# WATER QUALITY MEMORANDUM

## Utah Coal Regulatory Program

SUBJECT: 2009 Second Quarter Water Monitoring, CW Mining Company, Bear Canyon Mine, C/015/0025, Task ID # 3334

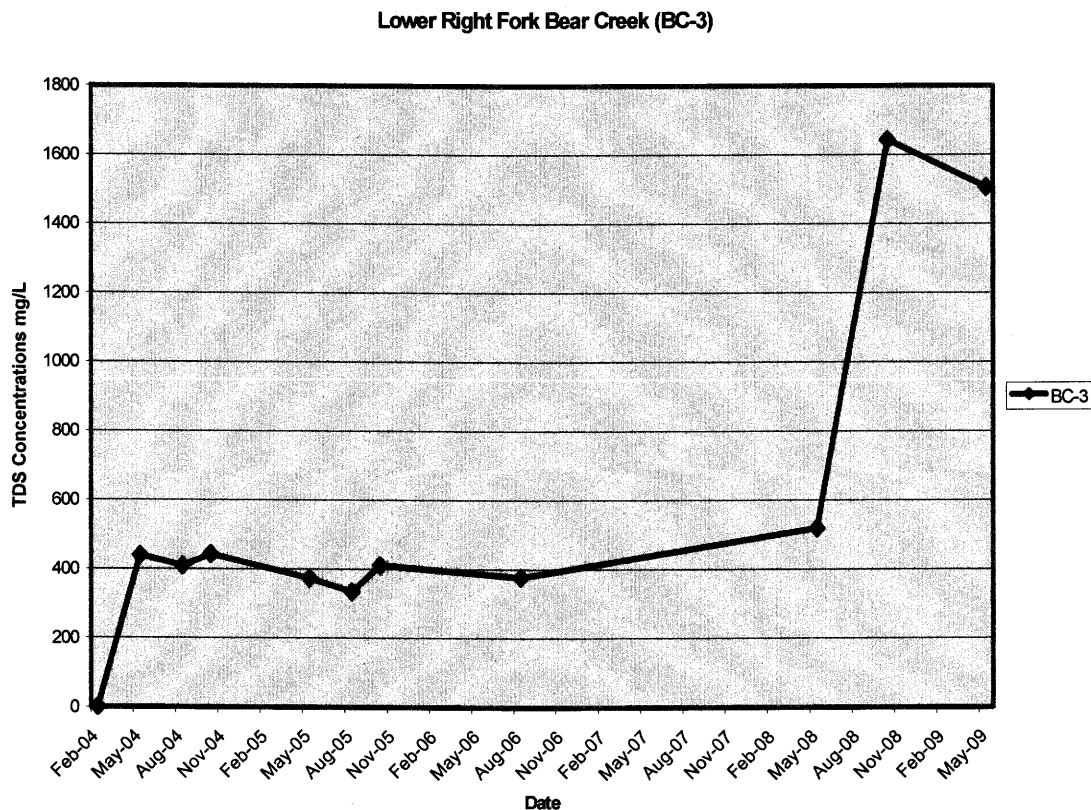
Sample BC-3 at the Lower Right Fork of Bear Creek has shown a recent increase in the levels of Total Dissolved Solids (TDS) since Fall 2008. Prior to this increase, TDS levels have averaged around 400 mg/L since 2004 (see chart below). Other water quality parameters such as dissolved calcium, dissolved potassium, hardness, sulfate and others were also outside of two

standard deviations during the October 2008 and May 2009 sampling.

- Sample BC-3 at the Lower Right Fork of Bear Creek has shown a recent increase in the levels of Total Dissolved Solids (TDS) since Fall 2008. This indicates that excess sediment may be discharging into the creek. The operator should evaluate sediment controls in this area and determine if there is any mitigation needed to control the level of sediment entering the water body.
- UPDES Sample 004 exceeded the 30-day average discharge limitation of 500 mg/L for TDS during May/June 2009. More data points are recommended to be collected within the 30-day period to determine if UPDES compliance point 004 is meeting effluent standards.
- Depth to water levels (75-78 feet) reported in wells SDH-2 and SDH-3 is questionable when previous data have shown that the groundwater surface averages approximately 1,500 feet below well casing. These measurements should be reevaluated to determine an
